Appendix 1:

Information requested under Clause 23(1) First Schedule of the Resource Management Act 1991

Planning, statutory and general matters	2
Transport matters – Martin Peake, Progressive Transport Solutions	4
Stormwater and flooding matters – Amber Tsang, Healthy Waters, Auckland Council	6
Geotech – Frank Havel, Auckland Council	16
Ecology – Nick Goldwater, Wildlands	16

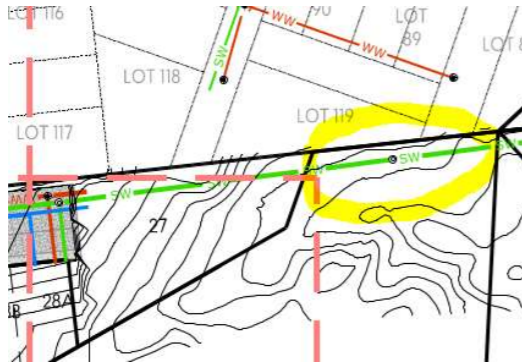
#	Information category	Further information requested	Reasons for request	Applicant's response
		plans, that would comply with the requirements of E38.8.1.2 (1) and (2).		
Stormwater and flooding matters – Amber Tsang, Healthy Waters, Auckland Council				
SW1	Site feature – contour and overland flow path (OLFP)	<p>Figures 1, 2 and 3 in Section 1.3 of the SMP present contour information. It is unclear from the explanation whether the contours are from SurveyWorx or from Auckland Council GeoMaps. They may not be consistent with the actual ground contours after recent earthworks.</p> <p>Likewise it is not clear whether the OLFP shown in other figures such as Figure 8 are the Auckland Council GIS OLFP or the actual OLFP after recent earthworks.</p> <p>How does this information differ from the actual topography considering the bulk earthworks indicated on GeoMaps's aerials photo dated 2022 (refer to snapshot below)?</p> <p>What are the current OLFP alignments across the site considering the earthworks that have been undertaken within the plan change area?</p> <p>Please update the SMP content as necessary to show current contours and OLFP.</p>	Correct understanding and assessment of contours and OLFP are required to inform the most suitable methods of stormwater management for future development enabled by the proposed plan change and the potential effects of the plan change.	<p>An amended SMP is included in Appendix 8.</p> <p>Section 1.3 has been updated to make it clear what Figure shows 'current' contours vs the figures which show the historical contours and flowpaths from Auckland Council Geomaps. This section now also includes some discussion around what re-shaping occurred on site and this is expanded on in Section 1.5.</p> <p>Appendix D has been added to the SMP which includes as-builts of all finished contours across the site. The as-built plans are prepared by Survey Worx.</p> <p>Envelope Overland Flowpath drawing, numbered 475 is attached within Appendix A. This clearly shows how flowpaths would be managed and directed across a potential future developed site.</p> <p>Section 1.8 of the SMP discusses the historic overland flowpaths which affected the site (noting these were minor). Section 6.2.8 of the SMP discusses future overland flowpath management.</p>
